# ENVIRONMENTAL ASSESSMENT

*Construction and Operation of a new Access Control Point at  
Lewis North, Joint Base Lewis-McChord, Washington*

**PUBLIC COMMENT AND AGENCY RESPONSE**

## Agency Response to Comments: Environmental Assessment for the Construction and Operation of a New Access Control Point at Lewis North, Joint Base Lewis-McChord

**Figure 2 Traffic Volume Redistribution at Dupont-Steilacoom Road and East Drive**

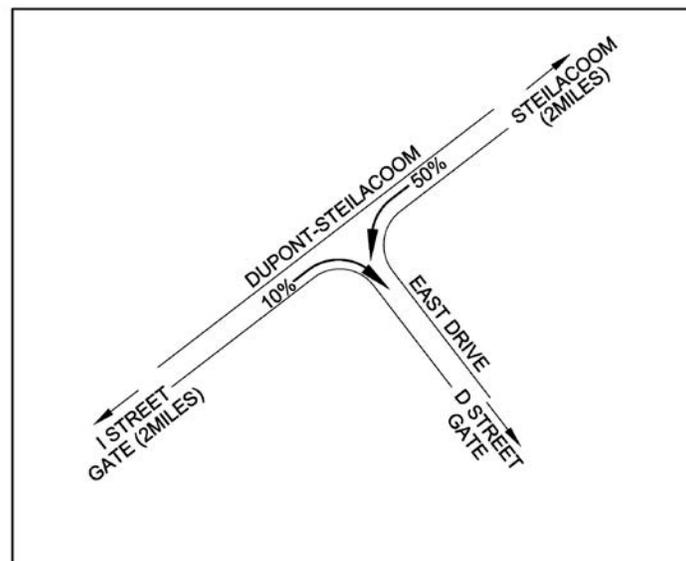
- Page 5-4 – Figure 2 notes the redistribution of traffic from the D Street gate; it is estimated the 195 vehicles would be diverted to the new ACP from the D Street gate, 187 of which would be turning left from Steilacoom-DuPont Road into the new gate access.

**Figure 3 Traffic Volume Redistribution at I-5 and North Fort Gate**

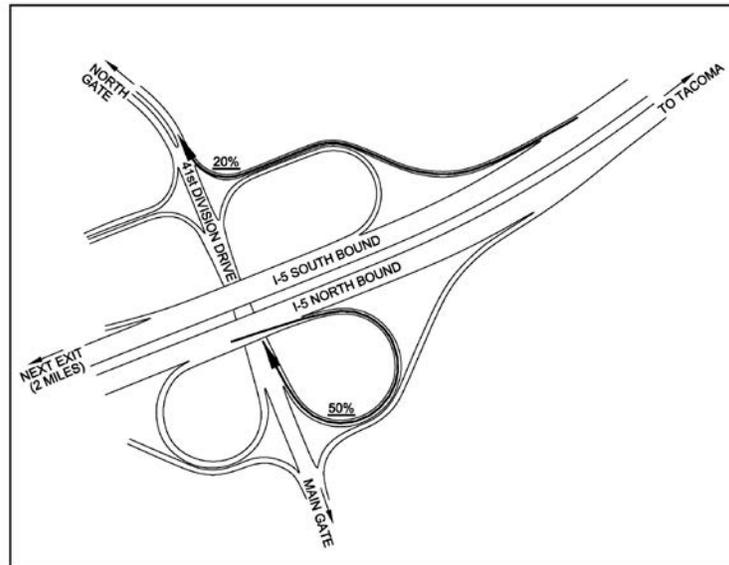
<p>Page 5-5; Figure 3 shows the redistribution of the North Fort Gate traffic which would be diverted to the new ACP via the Barksdale interchange. 264 vehicles would be diverted to the interchange- 135 from the north and 129 from the south and then proceed north on DuPont Steilacoom Road. This is a fairly large impact to the interchange.</p>	<p>Comment noted.</p>
<p>Page 5-1; Section 5.2 notes the future gate design demand. Based on the information presented, the City would concur with the volume noted for the new ACP.</p>	<p>Comment noted.</p>
<p>Based on information provided to the City, the proposed ACP is planned to serve 1294 vehicles in the AM peak. The future turning movement volumes for the Wharf Road intersection will need to be derived for use with the proposed future signal design to determine lane configuration and turn storage requirements necessary to accommodate the proposed ACP.</p>	<p>A peak hour (AM and PM) intersection operation analysis was completed for the intersection of Wharf Road and DuPont-Steilacoom Road to determine lane configuration and turn storage requirements.</p> <p>For AM peak hour, it was found that the Wharf Road and DuPont-Steilacoom Road intersection would have a LOS A (9<sup>ii</sup>) with a NBRT, and a LOS E (65) without. The PM peak hour analysis found that the subject intersection would have a LOS C (25) with the NBRT, and a LOS F (126) without the NBRT.</p>

- Page 5-5 – Figure 3 shows the redistribution of the North Fort Gate traffic which would be diverted to the new ACP via the Barksdale interchange. 264 vehicles would be diverted to the interchange – 135 from the north and 129 from the south and then proceed north on DuPont-Steilacoom Road. This is a fairly large impact to the interchange.
- Page 5-1 – Section 5.2 notes the future gate design demand. Based on the information presented, the City would concur with the volume noted for the new ACP.
